## REVISED RESPONSE TO REQUEST FOR ADDITIONAL INFORMATION

### APR1400 Design Certification

Docket No. 52-046

**RAI No.:** 252-8299  
**SRP Section:** 03.07.02 – Seismic System Analysis  
**Application Section:** 3.7.2  
**Date of RAI Issue:** 10/19/2015

Figure 47. Comparison of Transfer Functions of 18832 Node at Plant Grade Elevation (S2 Soil Profile, Uncracked Concrete Stiffness Case)

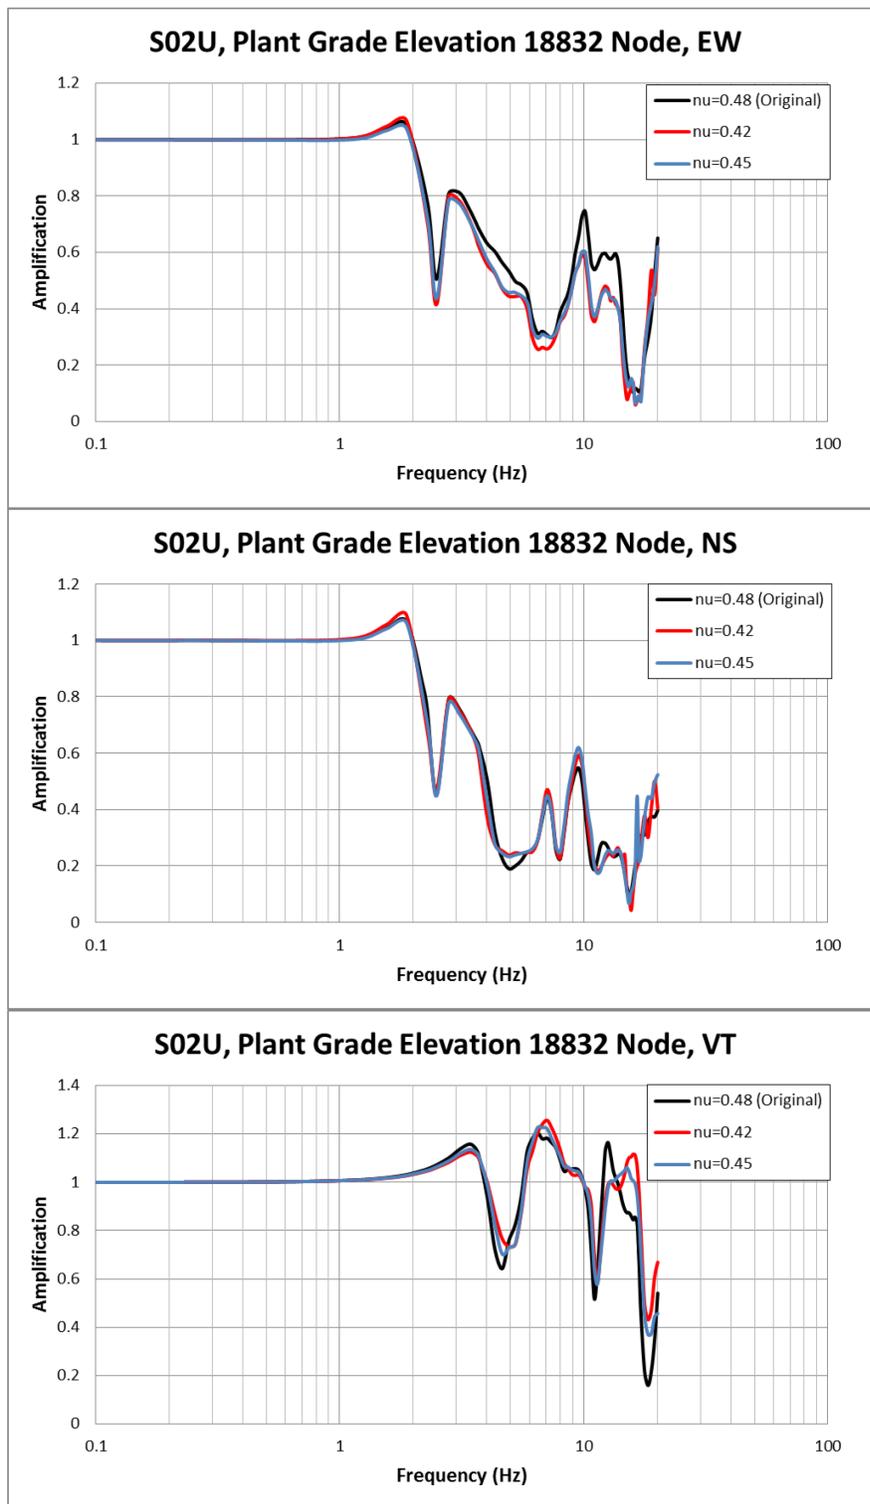
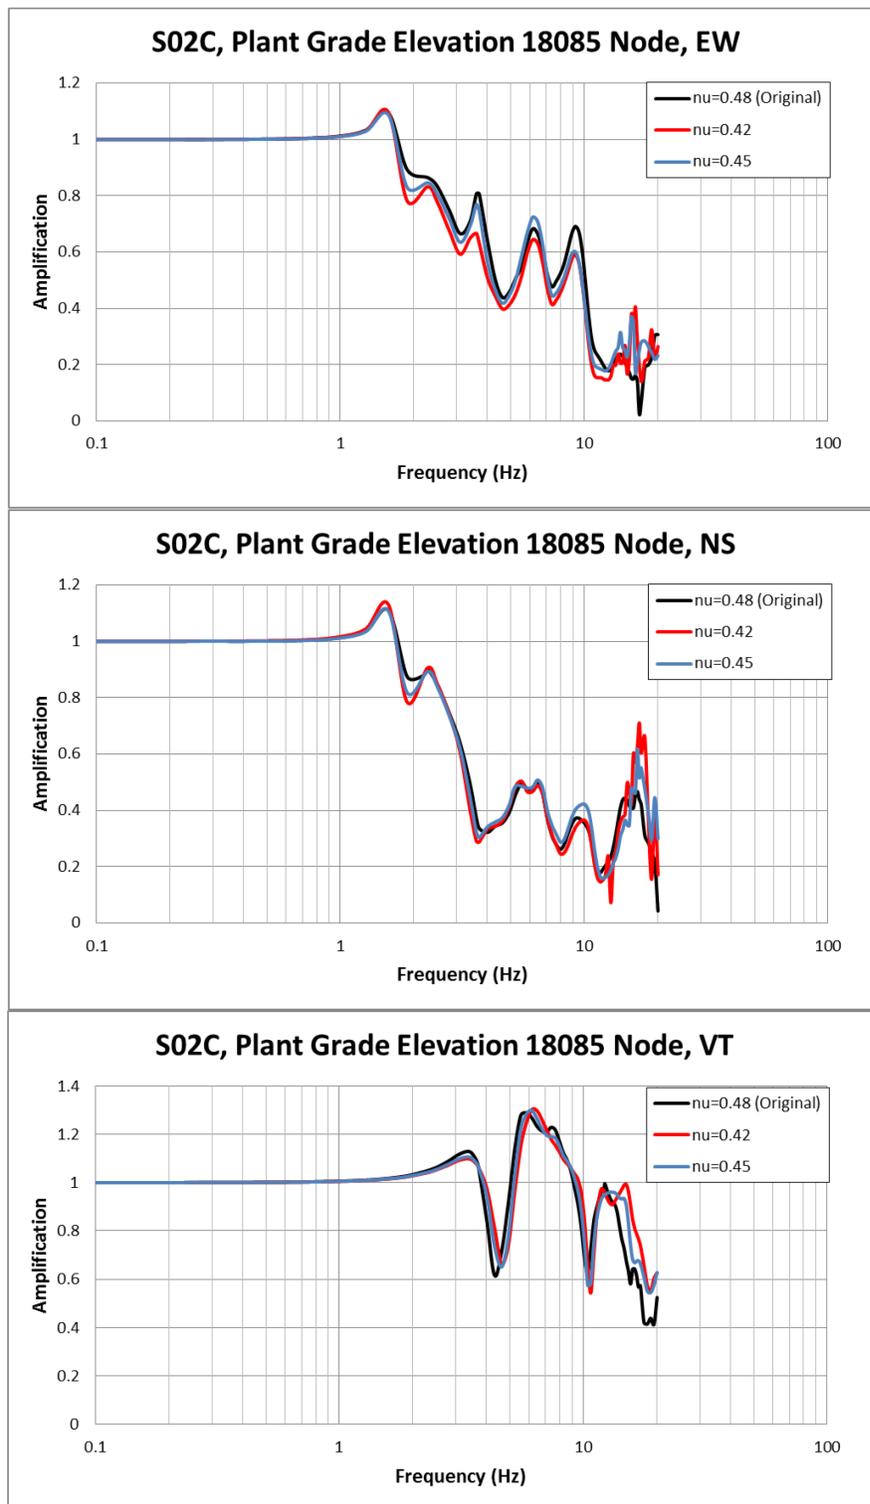
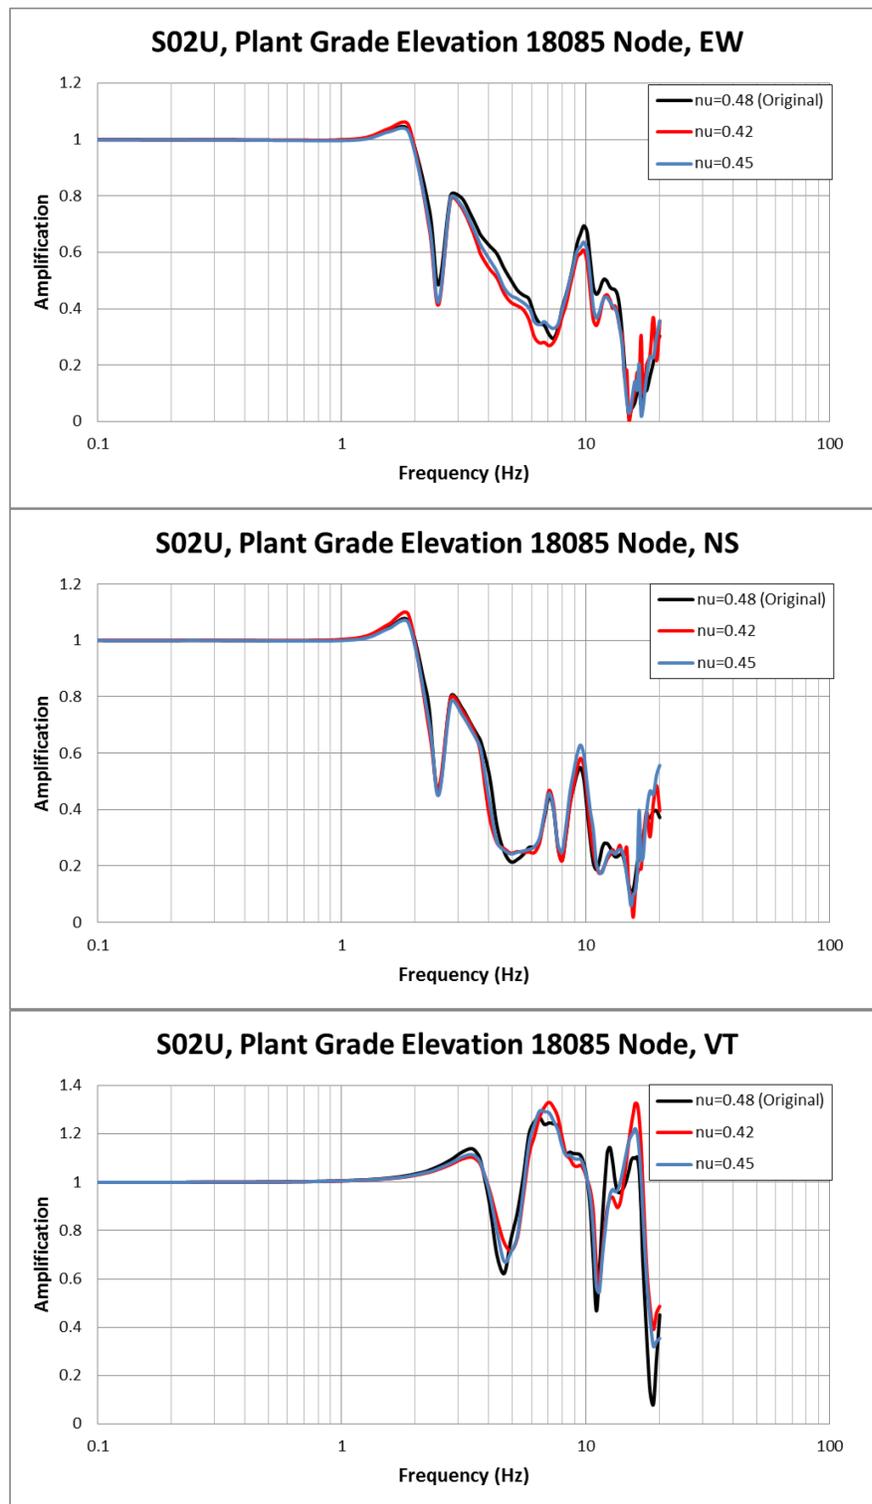
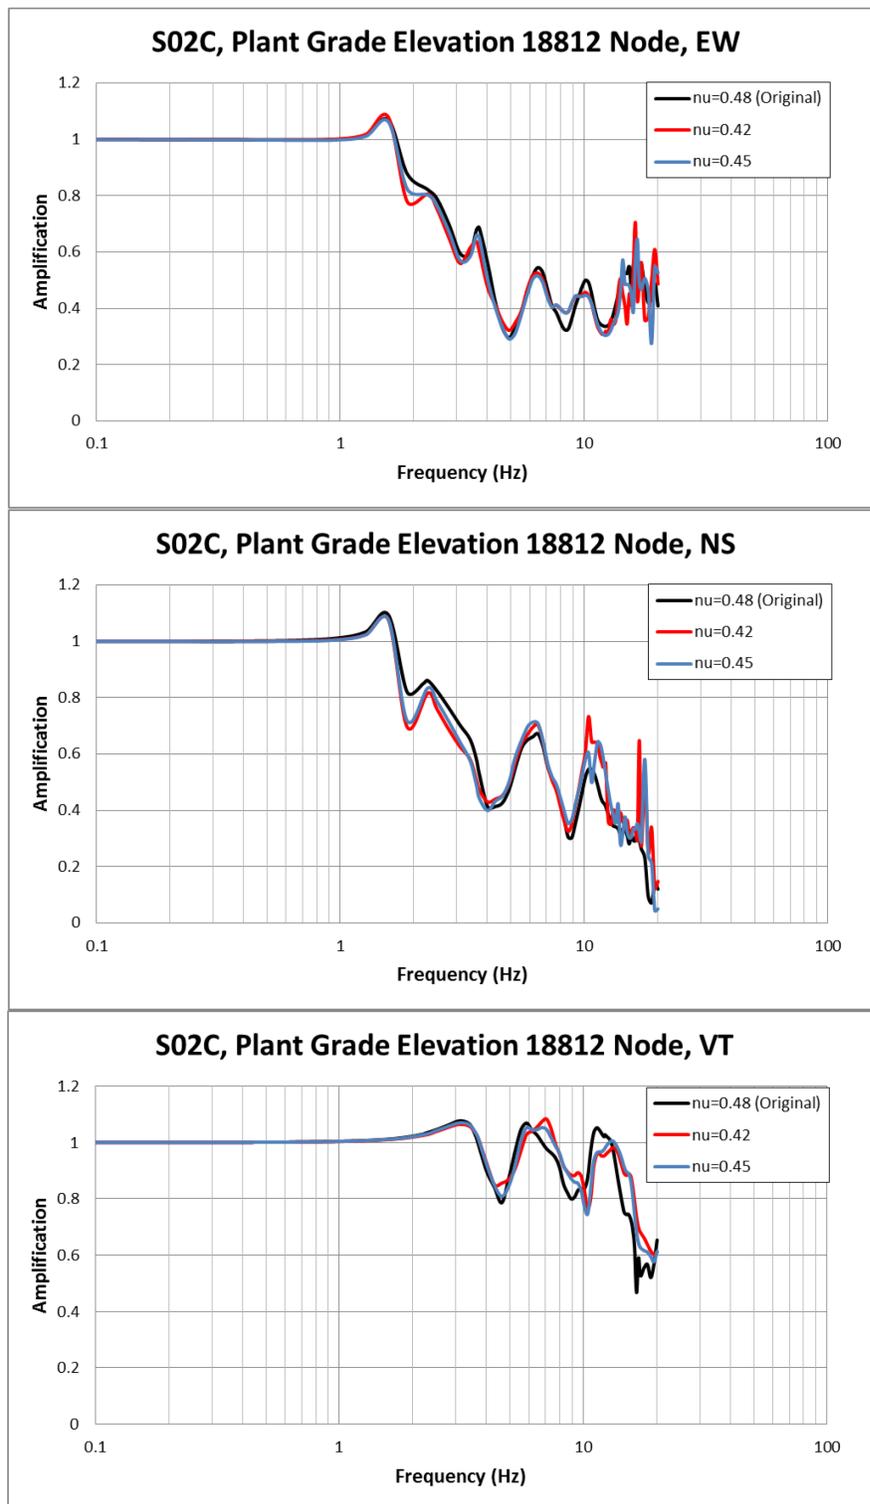
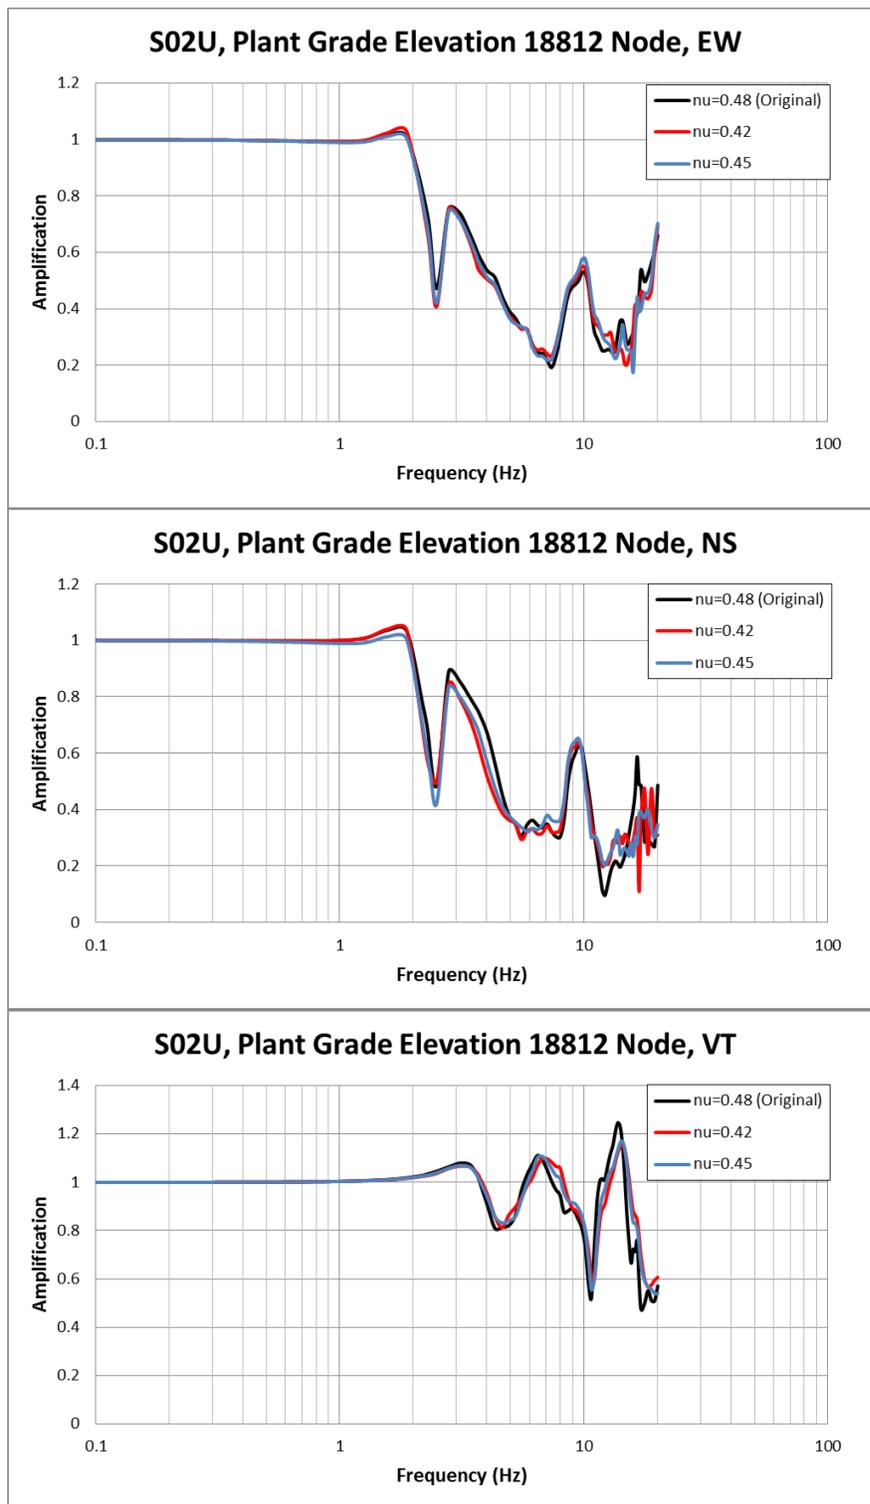
e) Poisson's Ratio Used in SSI Analyses

DCD Tables 3.7A-1 and 3.7A-2 show Poisson's ratios in the S1 and S2 soil profiles used for SSI analysis as great as 0.47 and 0.48 respectively. Based on staff experience, use of Poisson's ratio approaching these values may result in numerical instability of the SSI analysis results. Therefore, to assist the staff in evaluating the adequacy of the SSI analysis results based on the aforementioned soil profiles, the staff request the applicant to provide a demonstration (e.g. sensitivity study) that the assumed Poisson's ratio values do not produce numerical instabilities in the SSI results based on these profiles.

Using the modified soil profiles of S1 and S2, SSI analyses of NI models of both cracked and uncracked concrete stiffness cases are re-performed. Then, the transfer function results at NI basemat bottom and plant grade elevations obtained from the original SSI analyses and the re-performed SSI analyses in the sensitivity study are compared to judge the existence of numerical instabilities in the original SSI results. The locations of the selected nodes at basemat bottom and plant grade elevations using in the comparisons are provided in Figures 18 and 19. The comparisons of transfer function results for S1 and S2 soil profile cases are presented in Figures 20 through 51.

As shown in the comparisons of transfer functions presented in these figures, the transfer functions obtained from the original SSI analyses are quite similar and comparable to the transfer functions obtained from the sensitivity study re-performed SSI analyses. In addition, no abrupt changes or spurious peaks, which tend to indicate existence of

numerical sensitivities in the SASSI solutions, appear in the computed transfer functions of the original SSI analyses that have the maximum dynamic Poisson's ratio values of 0.47 and 0.48 as well as in the re-computed transfer functions that have the maximum dynamic Poisson's ratio values limited to 0.42 and 0.45. These results demonstrate that there is no numerical instabilities in the original SSI analysis results of the S1 and S2 soil profile cases.

**Figure 3-21 Connection between RCS Supports and Solid Elements**

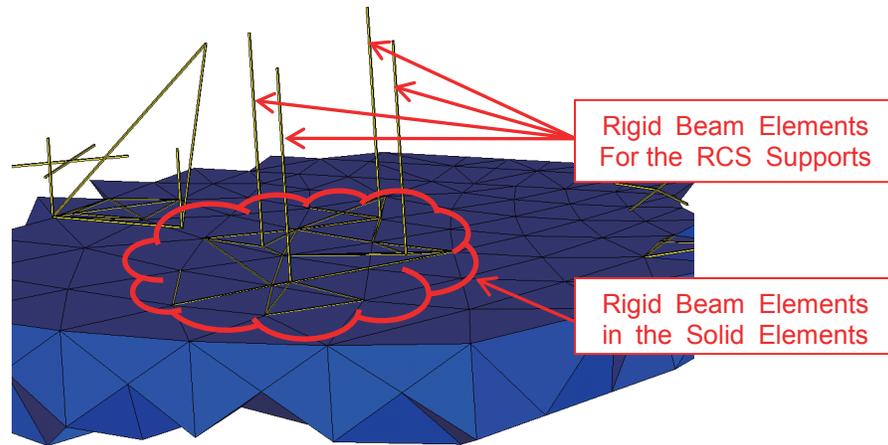
Staff review of APR1400-E-S-NR-14002-P finds that the nuclear island finite element model includes locations at which beam elements connect with solid elements (e.g. connections between the reactor coolant system model and the containment internal structure model). However, the staff did not find a description of how the degree of freedom compatibility is addressed for transitions between beam and solid elements. Therefore the staff requests the applicant to provide such description, including a graphical representation of the transition between beam and solid elements.

The degrees of freedom compatibility condition between the beam elements of the RCS and solid elements of the PSW and the SSW is satisfied by using rigid beam elements at the beam-to-wall support points covering the footprint of the RCS support brackets. The RCS supports are modeled as rigid beam elements and connected with other rigid beam elements in the solid elements which represent the PSW and the SSW. Figure 3-21 shows the connection between the RCS supports and the solid elements.

Add Figure 3-21 to next page of Figure 3-20.
